Index 102-602 Two-Lane and Multilane, Work on Shoulder

LAST REVISION 11/01/21	REVISION	DESCRIPTION:	 FY 2022-23 STANDARD PLANS	TWO-LANE AND MULTILANE, WORK ON SHOULDER	INDEX 102-602	SHEET 1 of 2
---------------------------	----------	--------------	--	--	------------------	-----------------

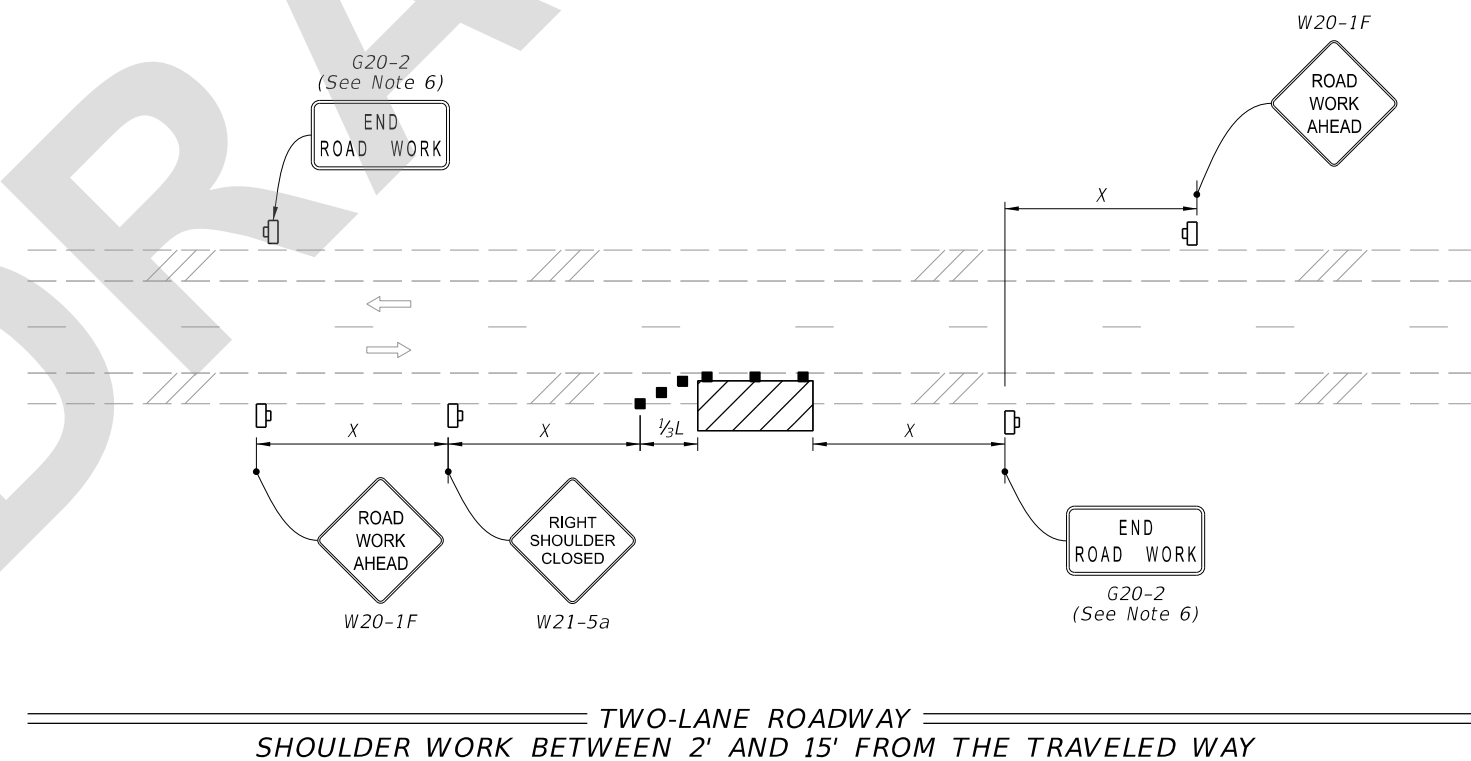
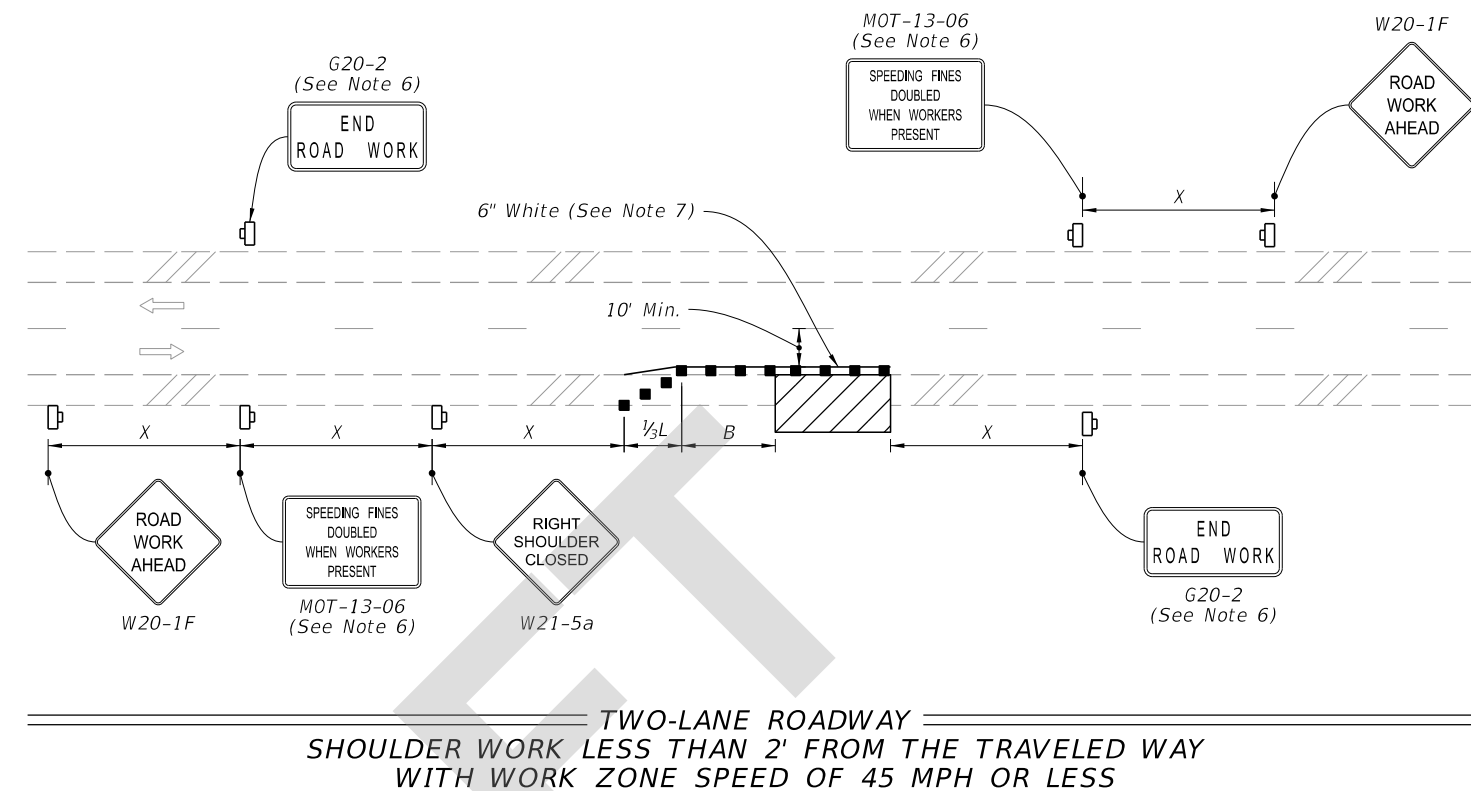
Changed Note 3 to revert to the previous duration that allowed engineers to omit signs and channelizing devices for work operations 60 minutes or less. changed "ridable shoulder" language to "4' or greater paved shoulder to be clear as to what we mean and not introduce a new term.

COMMENT: The original note change removing the duration note of 60 minutes or less, and requiring signs and channelizing devices for work activities other than Litter and mowing was in my opinion a solid step towards increasing the safety of workers performing tasks on the shoulder.

With the level of distracted drivers and increased incidents involving shoulder work related accidents, I recommend that a note be added requiring a TMA shadow vehicle be required for work 60 minutes or less, 2' – 15' from the travel-way, other than mowing and litter operations.

COMMENT: Is the 4-ft paved shoulder provision intended to apply to all roadway types (i.e., limited access facilities vs. Arterials/Collectors)?

RESPONSE: While the original intent behind removing the short-duration (60 mins. or less) allowance to omit signs and channelizing devices was done in an effort to increase the usage of advanced signage and delineation of the work area. It also had the unintended effect of increased worker exposure during the setup and removal of devices. In particular, for work operations that take less time to complete than the time to setup the TTC devices. However, while there is an allowance to omit the devices, proper judgment should be used and devices included where site conditions and traffic volume/speed indicate that advanced signing and channelization devices provide the safest traffic control application.

As for the use of TMAs, while there is currently no requirement to use them, the Department does not prohibit them. Additionally, the MUTCD provides guidance on the use of supplemental devices, such as TMAs, in addition to or in place of other advanced signing and/or channelizing devices.

No Change.

RESPONSE: No, only 4' or wider paved shoulder on non-limited access facilities are considered "Bicycle Facilities".

Change Made: Instead of revising the Note further, it has been decided to remove the redundant note from all relevant 102 Series Indexes. The FDM provides guidance on bicycle accommodations and Specification 102-3.4 will be updated to clarify the definition of a "Bicycle Facility" (i.e., existing marked Bicycle Lane or a 4' or greater paved shoulder on non-limited access roadways). **Note Deleted.**
